YARRABEE SOLAR PROJECT

Response to Submissions Report

Prepared for:
Reach Solar energy

Ref: 610.17428-R03-v1.0
October 2018

Figure 4 MinView Database Results Map

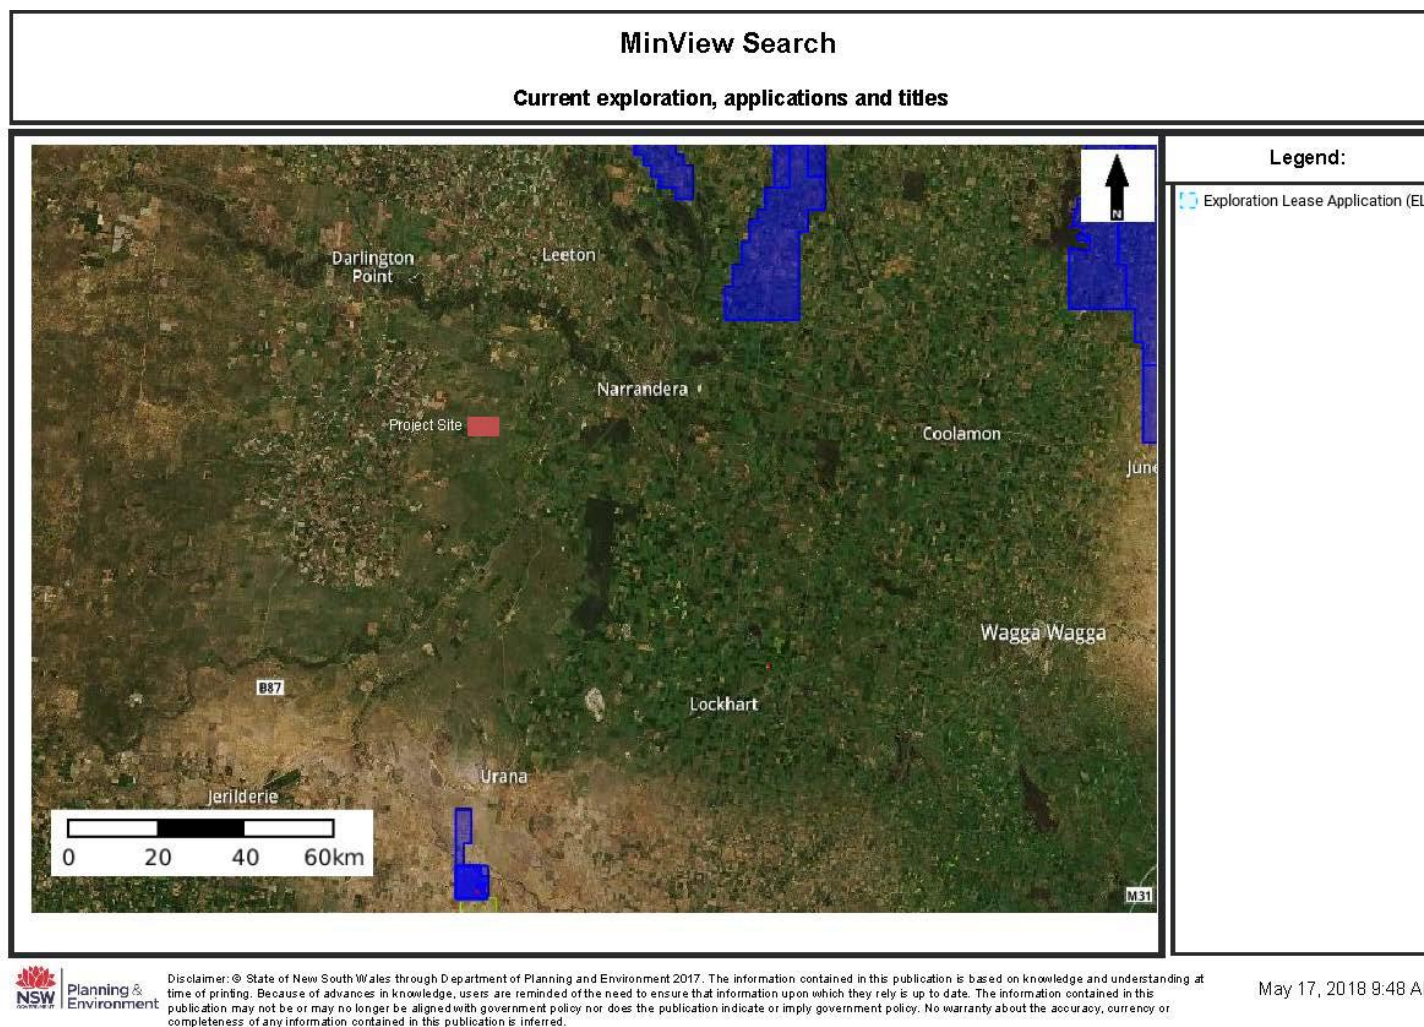
Respondent	Issues Raised	Response Reference
NSW Department of Planning & Environment – Resources & Geoscience		
	MinView Database findings map is not included in Figure 7.23, instead a repeat of the major projects map is included in the EIS.	Section <u>3.1</u>
NSW Department of Industry – Crowns Lands and Water		
	A viable and appropriately licensed water supply needs to be confirmed for the construction period. An impact assessment is required where this is to be accessed from a currently unlicensed extraction point or where the current entitlement is inadequate to meet the demands.	Section <u>4.1</u>
	The project approval should include the following condition: A Construction Environmental Management Plan (CEMP) should be prepared, including detailed erosion and sediment control measures.	Sections <u>4.2</u> & <u>4.3</u>
	Works within waterfront land should be undertaken in accordance with the Guidelines for Controlled Activities on Waterfront Land (NRAR 2018).	Section <u>4.4</u>

The MinView Database findings map was omitted from the EIS in error. It is included in this Response to Submissions Report - refer **Figure 4**.
